Access Compliance Report

Public Rights-of-Way

(Curb Ramps)

Intersection ID: 26134	Main Street: NUTHATCH_CT	Cross Street: SANDPIPER DR	Location:	N
ADA ID: 6E6B10279CFB	Ramp Type: PerpDiag	Initial Pass/Fail: Fail	Overall Compliance: No	Severity Score: 21.25
Codes/Mitigation Info/Possible Solution		Field Measurements/Component Compliance

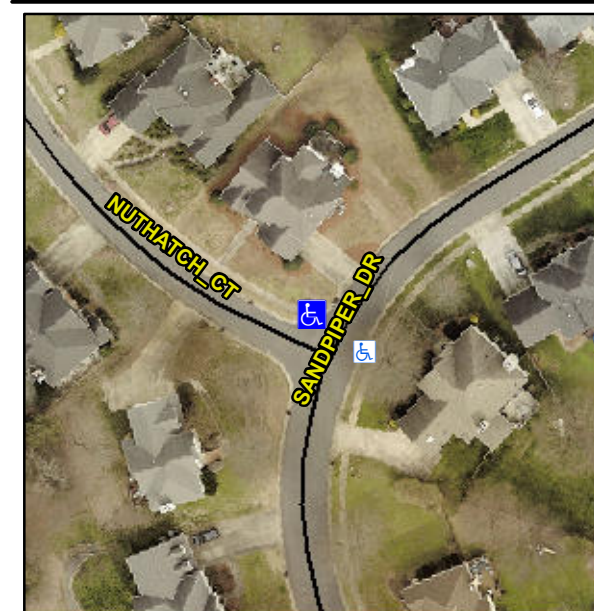
Not Found, R304.5.1, R304.5.3

Compliance	Description	Data	Compliance	Description	Data
N/A	Ramp Length (in)	98.0	Yes	Ramp Slope (%)	7.3
No	Ramp Width (in)	40.5	No	Ramp XSlope (%)	6.6
N/A	Flare Type LT	N/A	N/A	Flare Type RT	N/A
N/A	Flare Slope LT (%)	N/A	N/A	Flare Slope RT (%)	N/A
N/A	Flare Traversable LT?	N/A	N/A	Flare Traversable RT?	N/A
N/A	Landing Length (in)	N/A	N/A	DWS Provided?	N/A
N/A	Landing Width (in)	N/A	N/A	DWS Contrast?	N/A
N/A	Landing Slope (%)	N/A	N/A	DWS Length (in)	N/A
N/A	Landing X Slope (%)	N/A	N/A	DWS Full Width?	N/A
N/A	Landing Curb? (Y/N)	N/A	N/A	DWS Offset (in)	N/A
N/A	Shared Landing?	N/A			
N/A	Gutter Ponding?	N/A	N/A	Gutter Slope (%)	N/A
N/A	Gutter Lip Ht (in)	N/A	N/A	Gutter X Slope (%)	N/A
N/A	Painted X Walk1?	No	N/A	Painted X Walk2?	No
	X Walk 1 Direction	To SW		X Walk 2 Direction	To SE
N/A	X Walk 1 Width (in)	N/A	N/A	X Walk 2 Width (in)	N/A
	X Walk 1 Slope (%)	0.3		X Walk 2 Slope (%)	2.0
	X Walk 1 X Slope (%)	3.7		X Walk 2 X Slope (%)	1.0

Remove & Replace Curb Ramp With Two New Directional Ramps or Equivalent.
